Addendum 3: Global technical regulation No. 3

Global technical regulation concerning the motorcycle brake systems

Amendment 2

Established in the Global Registry on 12 March 2015

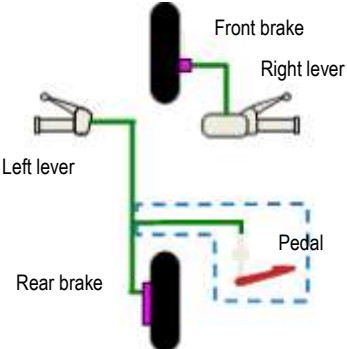
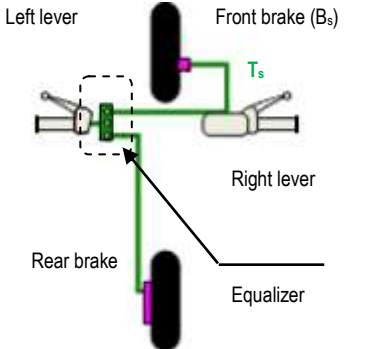
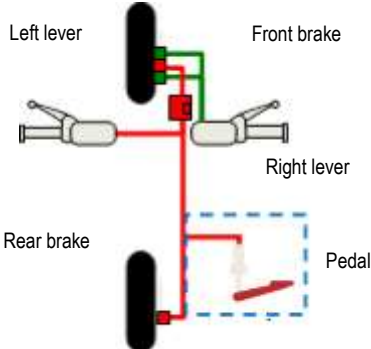
6. Gtr No. 3, paragraph 3.1.9., requires that "two separate brake systems may only share a common brake if a failure in one system does not affect the performance of the other", limits the application of CBS.

7. Not all CBS architectures can meet this requirement although they will outperform conventional brake systems.

8. Not all CBS architectures, however, existed at the time the original CBS requirements were drafted (in the 1980s) and it is, therefore, understood that GRRF did not consider such systems when introducing this requirement.

9. In order to ensure that, in case of a failure in one system, the performance of the other system still equals that of a conventional system, it is proposed to allow two separate brake systems to share a brake and/or a transmission, provided that the other system meets the single brake system performance requirements in case of a failure of such shared components(s). To that end, a failure test is proposed for CBS brake systems of architecture B. Italy is of the opinion that such a failure test requirement should ensure the acceptance of such a CBS in terms of demonstrated robustness and guaranteed minimum braking performance.

"3.1.9. In cases where two separate service brake systems are installed, the systems may share a common brake a common transmission, or both if the requirements of paragraph 4.12. are met."

CBS Architecture B

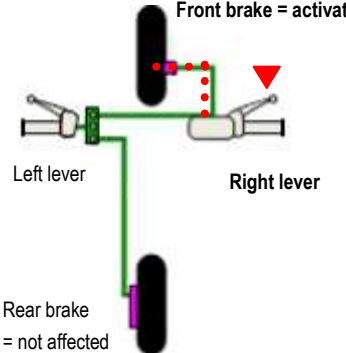
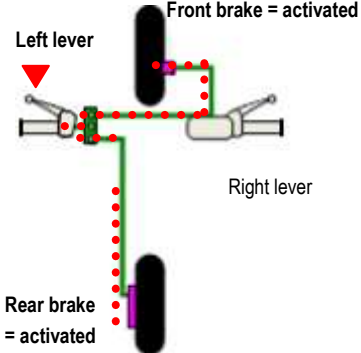
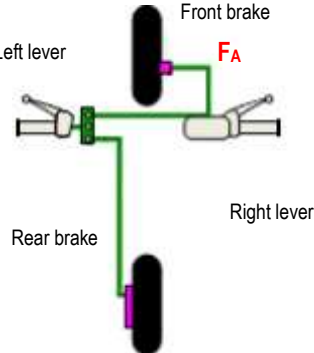
21. Architecture B is an example of a CBS that shares a transmission (Ts) and a brake (Bs).

22. While a failure in e.g. the "front system" (F_A) may affect the performance of the CBS, the rear system (operated by the left lever) will continue to be operational.

23. In order to ensure that, in case of a failure in one system, the performance of the other system still equals that of a conventional system, it is proposed to allow that two separate brake systems share a brake and/or a transmission, provided that the other system meets the single brake system performance requirements in case of a failure of such shared component(s). To that end, a failure test is proposed for CBS brake systems of architecture B. Italy is of the opinion that such a failure test requirement should ensure the acceptance of such a CBS in terms of demonstrated robustness and guaranteed minimum braking performance.

"4.12. CBS failure test
